ATTACHMENT 6A

Emergency Plan Marked-up Pages – Quad Cities Station

Exelon Standardized Emergency Plan EP-AA-1000
and
Emergency Plan Annex EP-AA-1006

Affected Pages – Marked-up

Figure B-1a: Exelon Overall ERO Command Structure

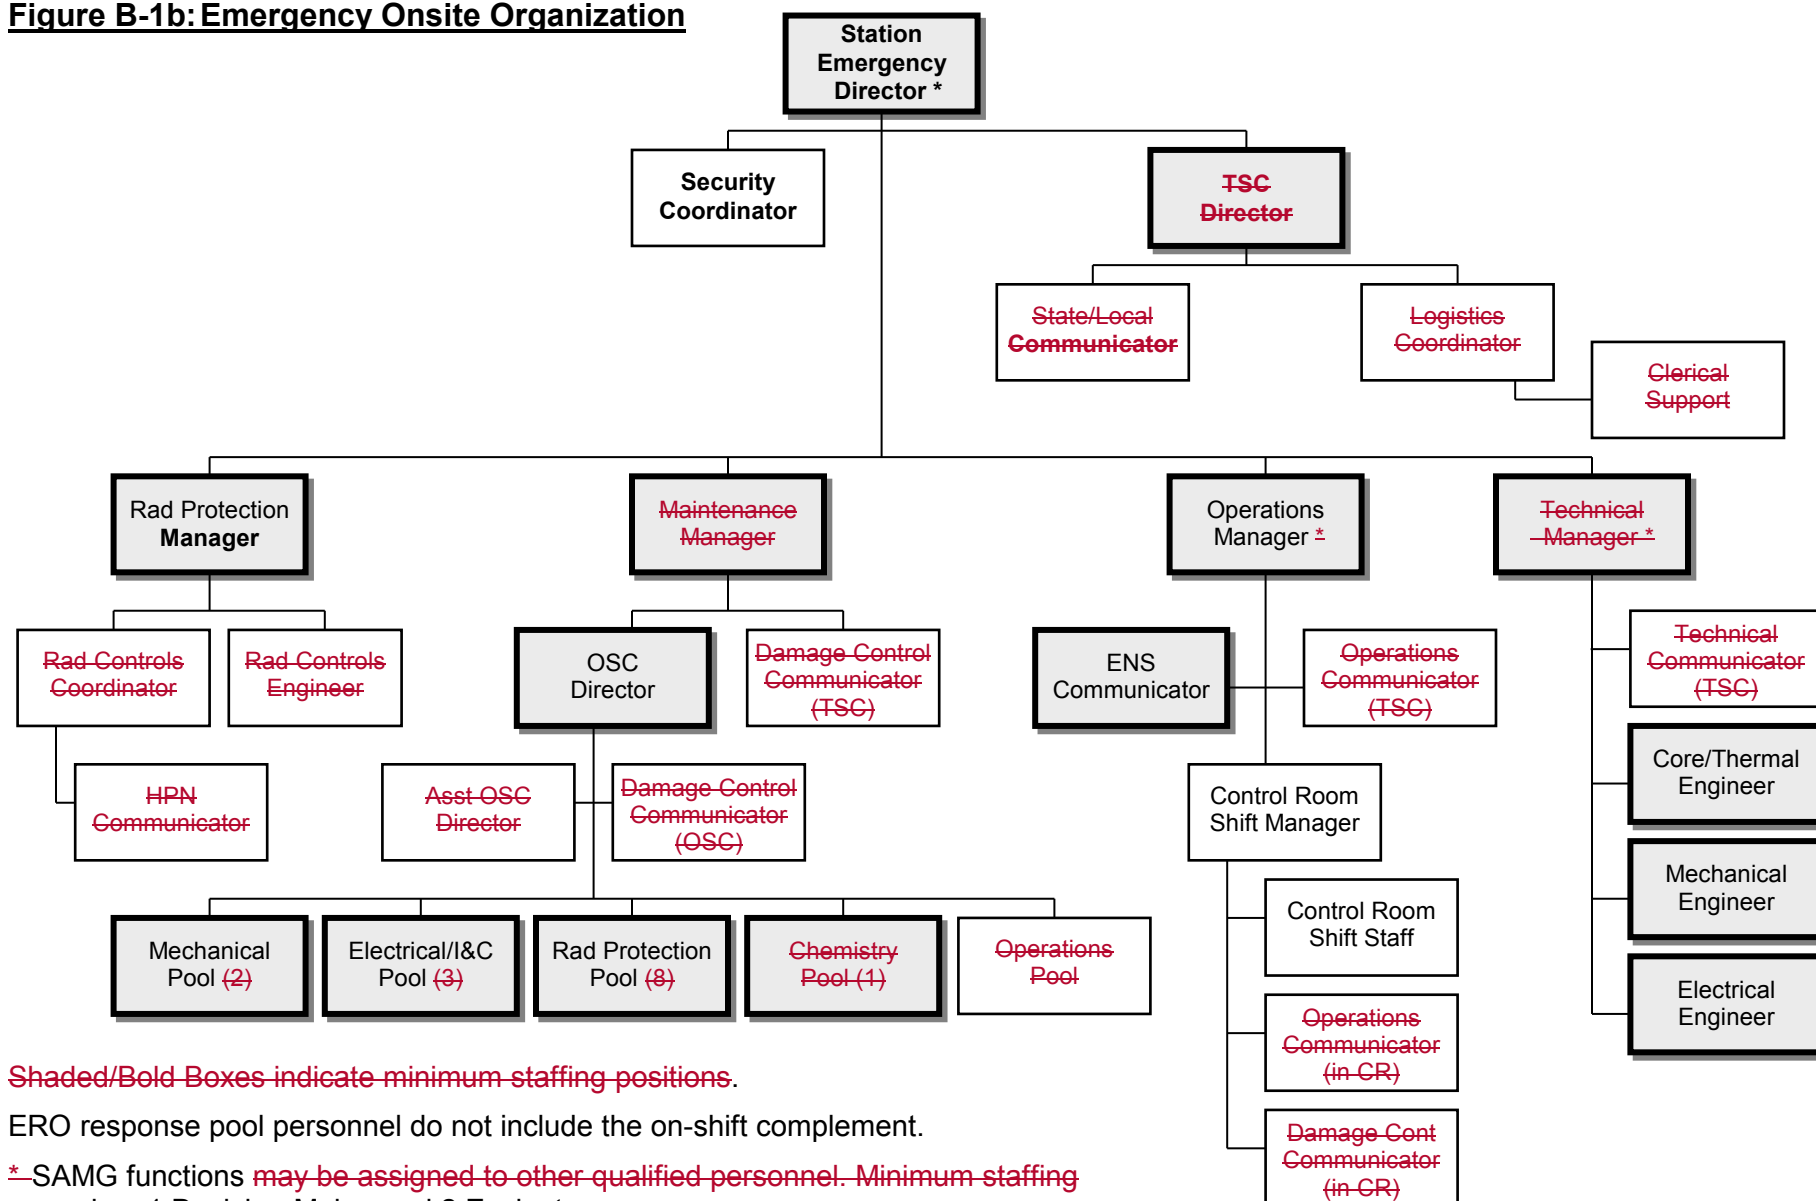
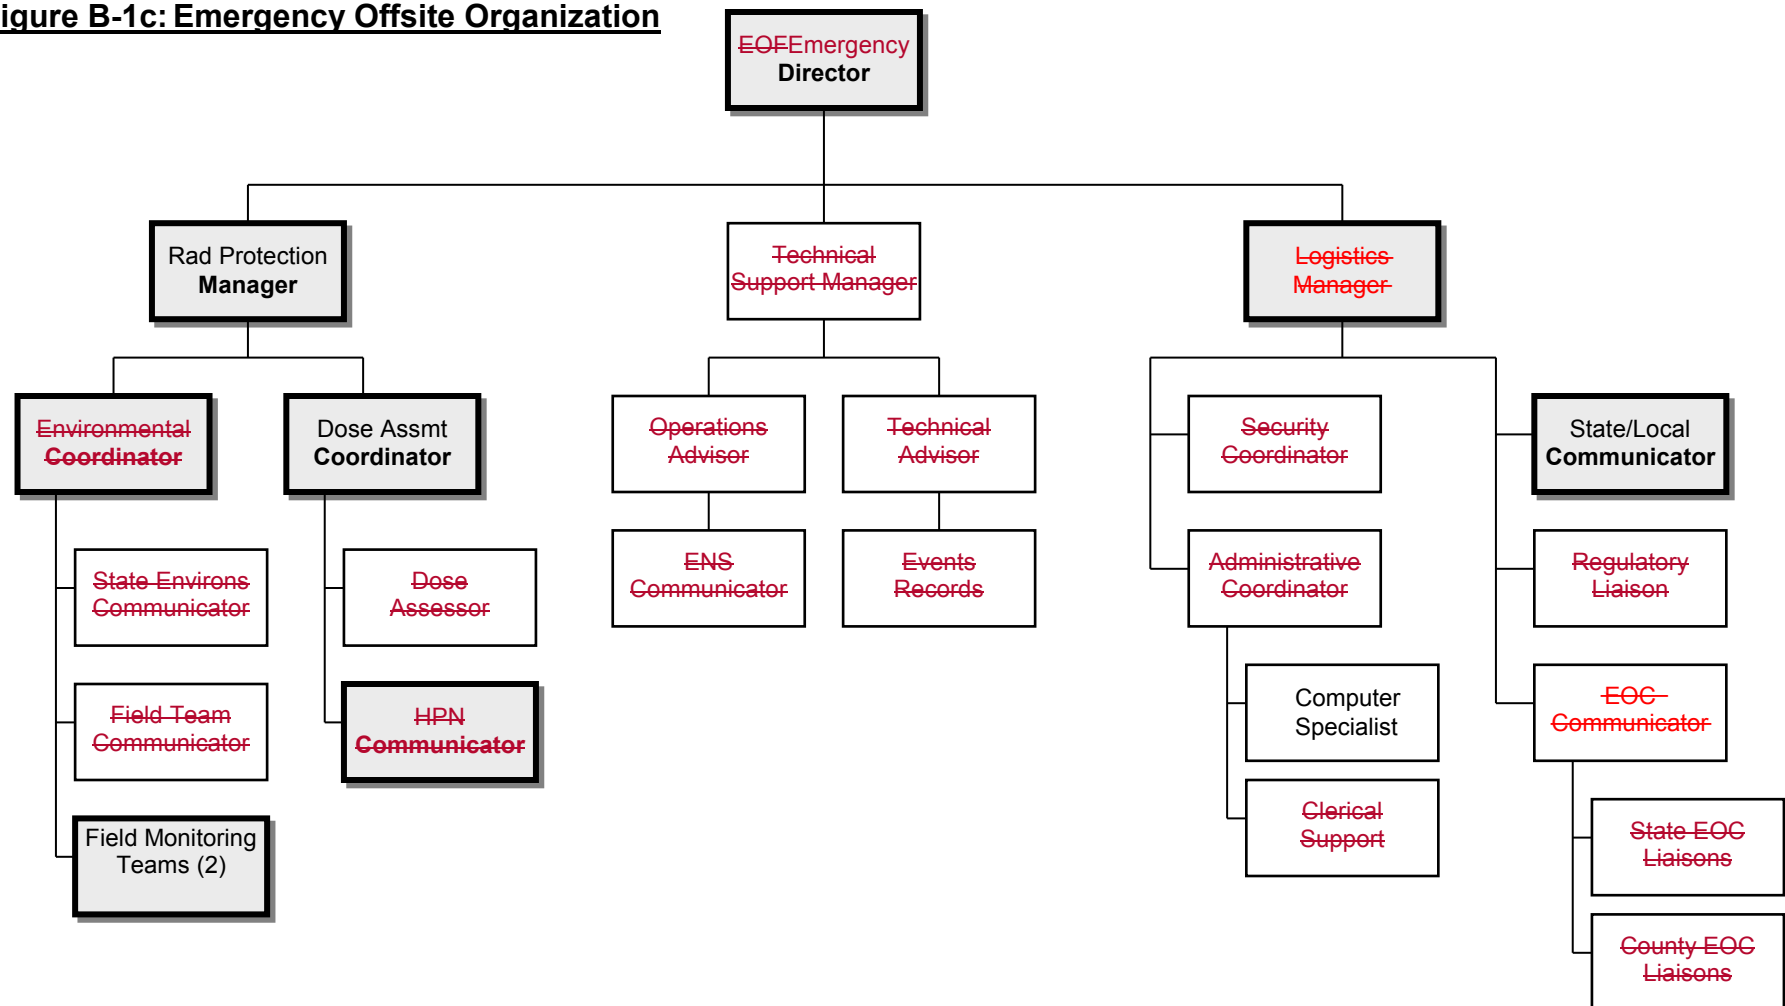
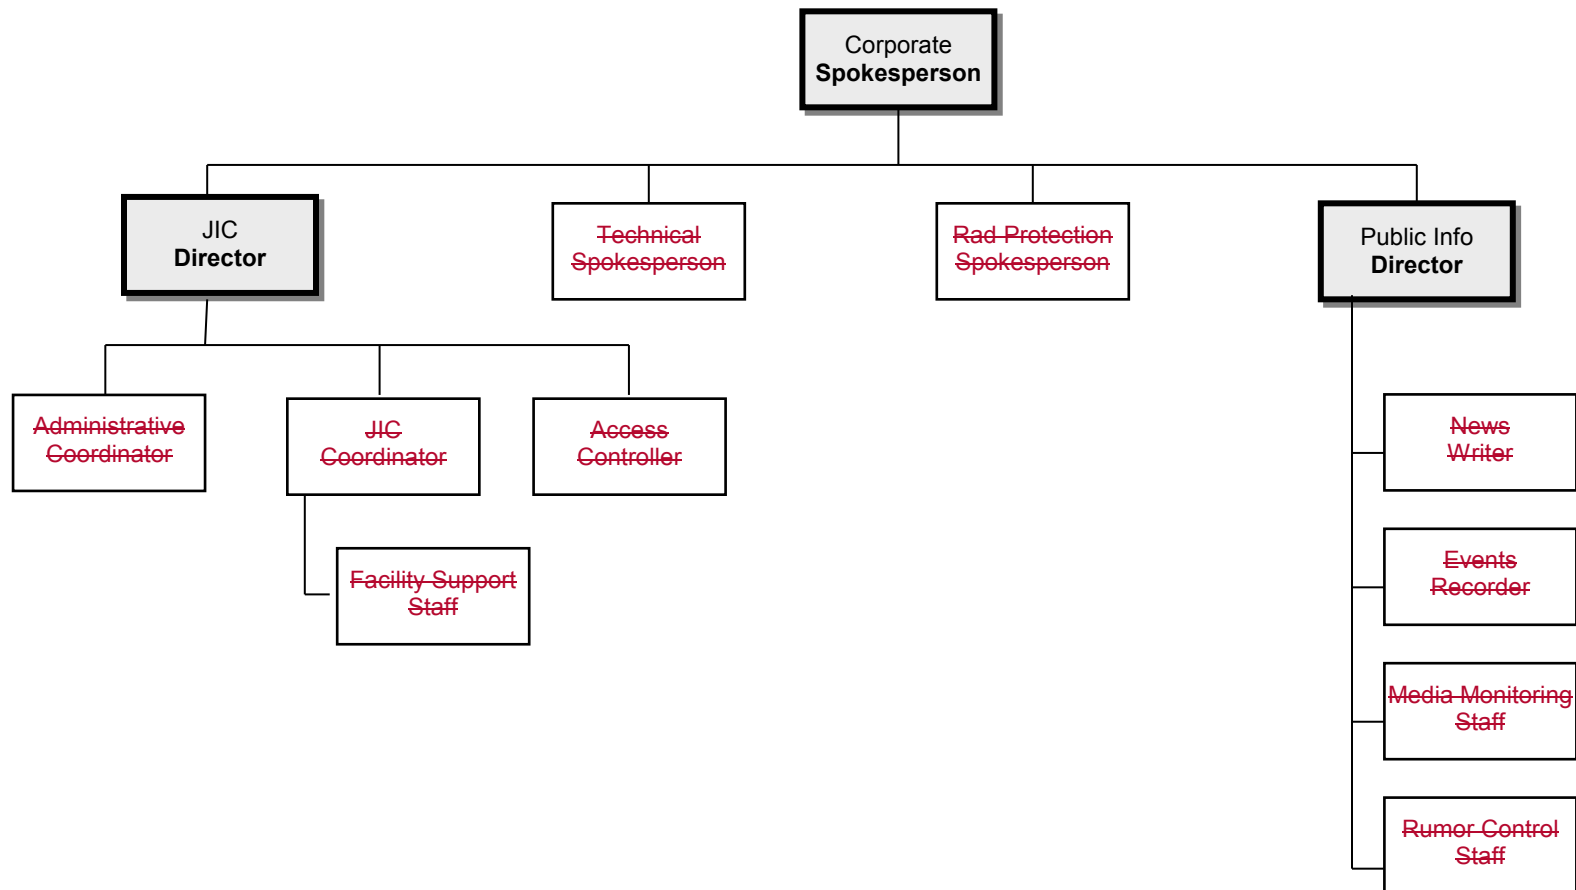
ERO staffing tables contained ~~within the station specific Annexin Appendix 5,~~ lists the key positions of the ERO ~~and the supporting positions assigned to interface with federal, state, and county authorities.~~ Figures B-1a through B-1d illustrates the overall emergency response organization. Section B.5 discusses specific responsibilities and the interrelationships for key positions.
